VALUE ENGINEERING CHANGE PROPOSAL MISSOURI DEPARTMENT OF TRANSPORTATION

Contract ID 120217-F01 **Job No.** J6I2010D

County St. Louis **Route** I-270 **Original Contract Amount** \$10,694,739.21

Eliminate MSE Wall #'s 002 & 003 VE

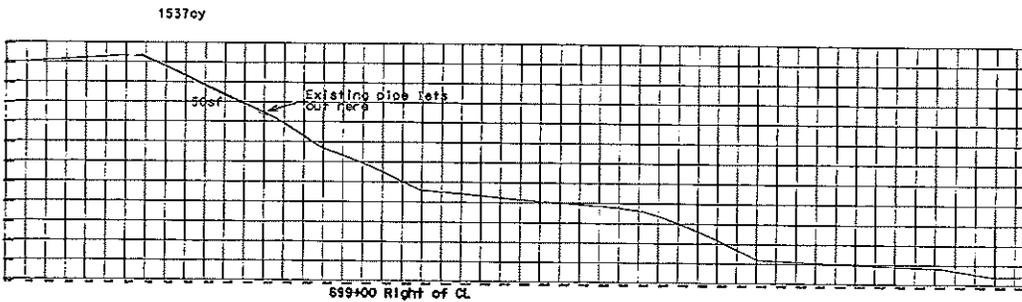
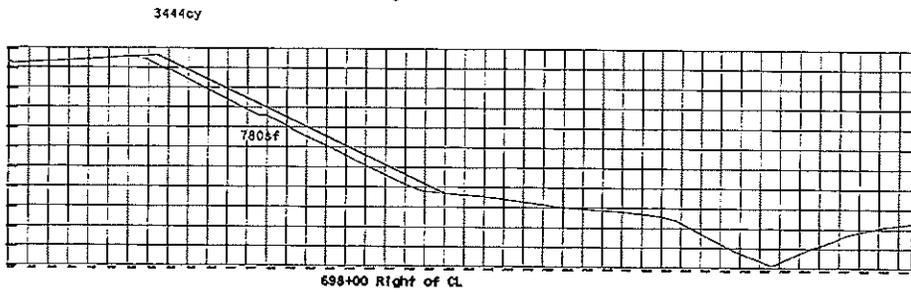
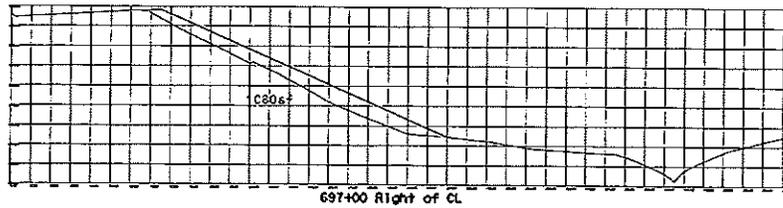
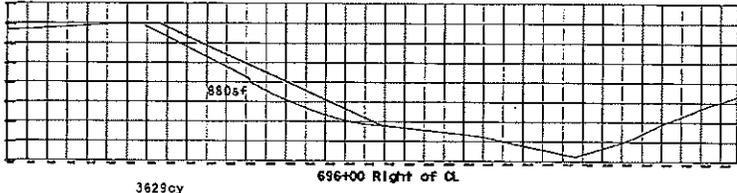
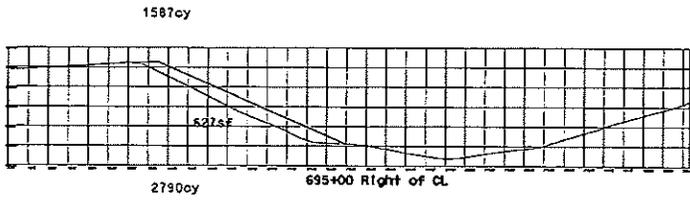
MSE wall #'s 002 & 003 will be eliminated near Marshall Road & I-270 and replaced with rock fill from excess on jobsite. Some of the additional rock fill will come from elimination of the originally proposed slope stabilization work along SB 270 from Sta. 640+42 to 644+45. Rock fill will be placed at approximately 2:1 slopes. The total projected excess material appears to be around 24,479 CY and will be divided up between the two sides of I-270 so that 2:1 slopes are achieved. To replace the rock slope stabilization work from Sta. 640+42 to 644+45 dirt will be imported from a location to be determined later to cover the existing berm in this area, then seeded and stabilized with erosion control blanket or similar. There is an existing box culvert beneath I-270 that crosses the path of walls 002 & 003. A pipe culvert is also present at the wall 002 location. MoDOT is currently checking to see if the box culvert and pipe culvert can withstand the addition of rock fill from the changes proposed in the VE. Quantities and pricing above may change depending on the outcome of MoDOT's analysis of the existing box culvert and pipe culvert.

No fill height requirement except following slopes on cross sections.

4' of max. fill over ex. 5x5 Box Culvert

4' of max. fill over ex. 36" RCP C.I.V
